CQIS DETAIL REPORT

VEHICLE: 2015 FOCUS,SE,4 DOOR ,SEDAN VIN: [REDACTED]  
 Engine : 1.0L 12V DI TC I3 GS 120PS FOX Odometer: 40,679 MILES  
 Operating Environ: WCC :  
 Vehicle Use : Rsp. Act:

SYMPTOM: 5 52 2 02 DRIVING PERFORMANCE STALLS/QUITS  
 ACCELERATION ALWAYS  
 Additional Symptom: Stalls on acceleration  
 Other Veh. With Concern: Severity Rating - Customer: Engineering:

VEHICLE: 2016 FOCUS,SE,5 DOOR ,SEDAN VIN:[REDACTED]  
Engine : 1.0L 12V DI TC I3 GS 120PS FOX Odometer: 78,143 MILES  
Operating Environ: WCC :  
Vehicle Use : Rsp. Act:

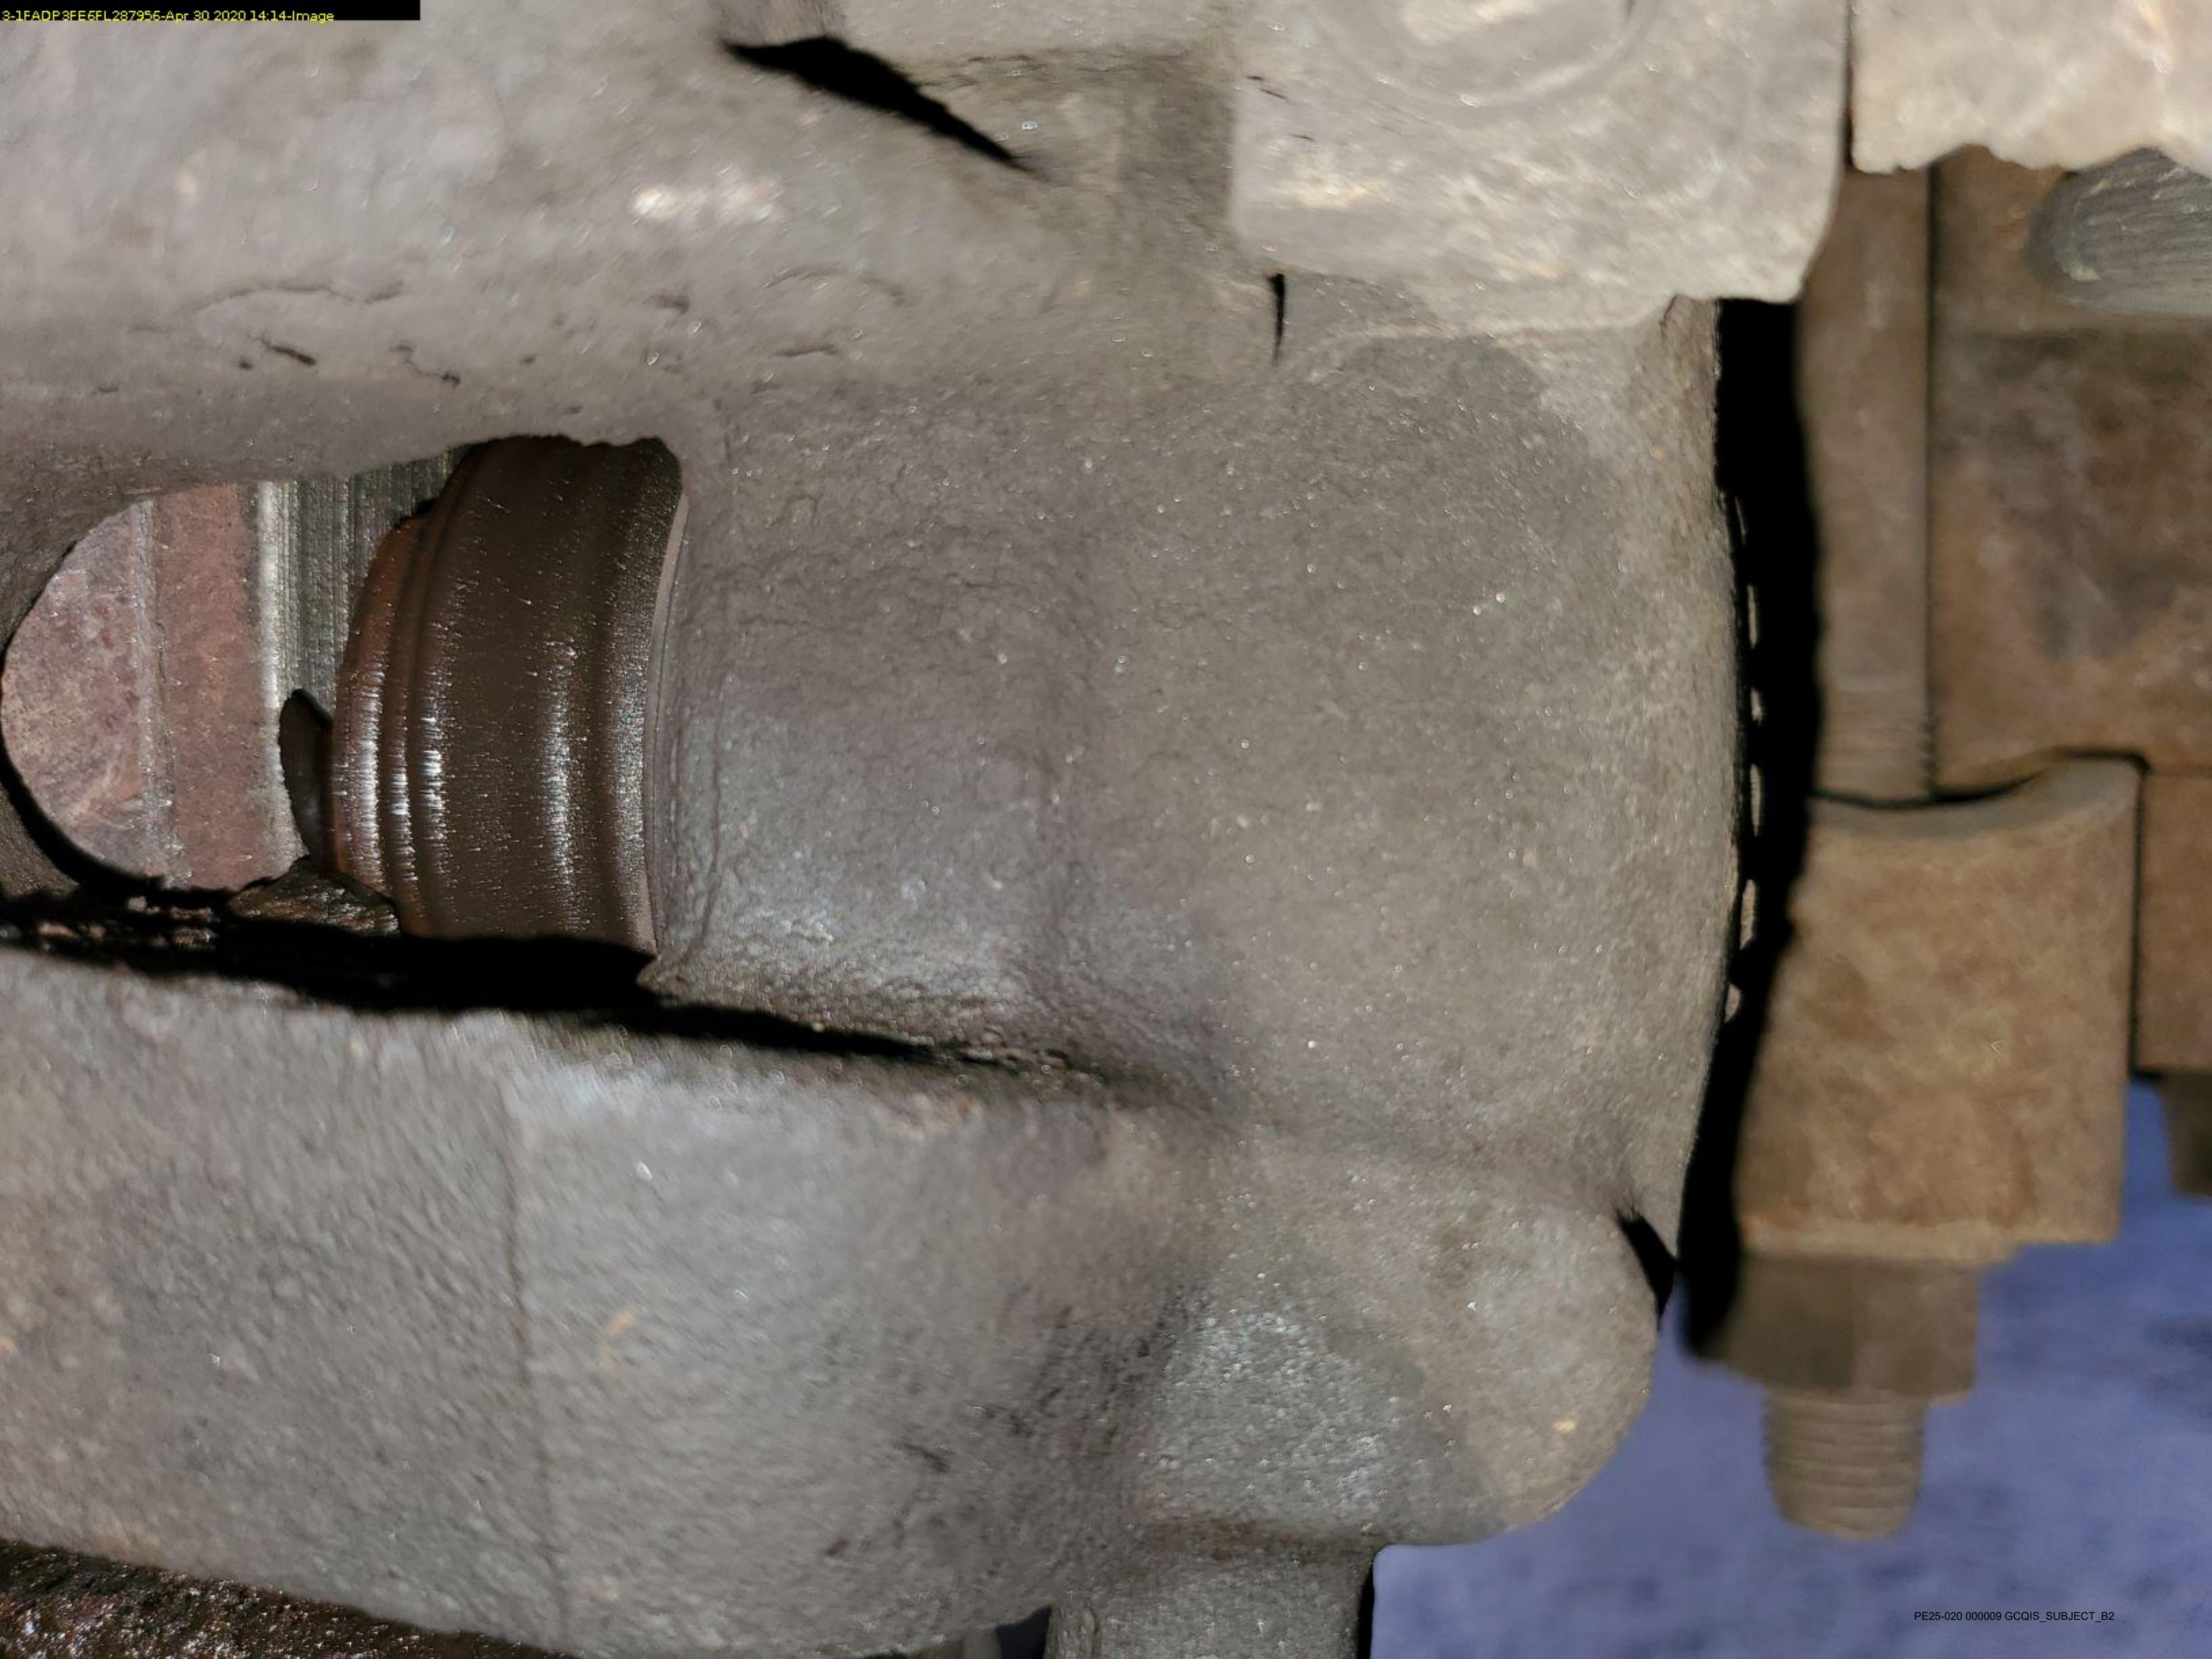
You know i am pretty sure we do not need prior approval. The warranty
administrator said we do as of february. the cost cap was done in
april. I was just looking for an approval code.
RECOMM 04/30/2020 03:27PM DPETE202
Hello [REDACTED] If prior approval is required for this engine, then the
description of the damages and the images that are requested for this
concern will be needed on this form to continue with the Prior
Approval process. Else if your warranty administrator had determined
that prior approval is not needed for this RO and your dealership,
then proceed with the necessary repairs as directed by the cost cap.
This form will remain as status Additional Information Required in
case that prior approval is required for this request. If so, then
please update with the required information. GASPA Additional
Information Required
CONCER 04/30/2020 04:34PM [REDACTED]
from the pictures you can see metal in the pan. the journals are

scored because they are oil starved. material from the belt got sucked
up into the pick up tube, staving the engine and turbo for oil.
RECOMM 04/30/2020 04:55PM [REDACTED] MSS - FCSD - TECH ASSIT CENTER
[REDACTED] The scoring damage can be seen on the camshaft caps. There
does not appear to be any damage to the short block components at this
point (ie. connecting rod or main bearings, cylinder walls). If you
suspect damage to these lower end components, they should be
inspected. If damage is present, upload photos to the form for further
review. Note: Metal debris in the oil pan and filter does not
automatically condemn the short block components without inspection
results supporting physical damage. Upon further review, it appears
the engine has already been replaced. The claim has already been
submitted in OWS for payment. Since the repair has been completed,
this would be considered a post approval request. To obtain an

CONCER 04/30/2020 06:32PM [REDACTED]  
 PRIMARILY THE DAMAGE TO THIS TURBO CHARGER WAS DONE BY THE OIL  
 STARVATION FROM THE BELT MATERIAL IN THE OIL PICK UP SCREEN. PICTURES  
 WHERE PROVIDED TO SHOW THE CAM JOURNALS AND CAM SHAFT HAVE SCORING ON  
 THEM

CONCER 04/30/2020 06:55PM [REDACTED]  
 A PRIOR APPROVAL WAS PERFORMED FOR THE TURBO CHARGER. THE ROOT CAUSE  
 OF THIS FAILURE IS THE BELT. IT IS BELIEVED THE TENSIONER CAUSED THAT  
 DAMAGE TO THE BELT. THE TENSIONER IS INTACT AND A PICTURE OF IT WOULD  
 NOT INDICATE ANY FAILURE WITH IT. THE DEBRI FROM THE BELT GOT SUCKED  
 UP INTO THE OIL PICK UP AND OIL STARVED THE MOTOR. THE MOTOR HAD  
 SIGNIFICANT DAMAGE AND PUT METAL SHAVINGS IN THE OIL PAN. THE CAM  
 JOURNALS AND CAM SHAFT SHOW SCORING.

RECOMM 04/30/2020 06:28PM [REDACTED] MSS - FCSD - TECH ASSIT CENTER  
 [REDACTED] Additional information is needed regarding the specific damage  
 to the short block internal components. Metal debris alone does not  
 condemn the internal components. Please provide the inspection results  
 for the connecting rod bearings, main bearings, and cylinder walls.  
 Upload photos of the damage supporting replacement (if available).  
 GCPA Additional Information Required

RECOMM 04/30/2020 07:29PM [REDACTED]  
[REDACTED] Thank you. This is the information we needed. A review of the contact 117216836 (long block request) found that the failure is most likely warrantable, there is just still some question as to extent of the damage and whether a REPAIR or REPLACE decision is most appropriate. Therefore, since the engine failure is most likely warrantable (whether the determination is to REPAIR or REPLACE), and the engine failure caused the turbocharger turbine shaft to become loose and the fins to contact the housing, turbocharger replacement is approved. GCPA Approved THGC402918

RECOMM 04/30/2020 07:42PM [REDACTED]  
[REDACTED] Thank you for taking the time to describe the damage found with the short block assembly. Since the oil pump belt failed causing loss of oil pressure and damage to the short block and cylinder head, proceed with long block replacement per the Cost Cap. Order a Remanufactured Long Block (base part 6006) through your parts department. If a remanufactured assembly is not available, order a new assembly. <P>Before installation, please review the service manual and literature provided with the replacement engine regarding intake manifold cleaning/replacement, priming the oil system, filling the cooling system, etc. <B>Note:</B> If the intake manifold is not attached/supplied with the assembly, it must be thoroughly inspected to ensure that it is free of any and all metal debris. If
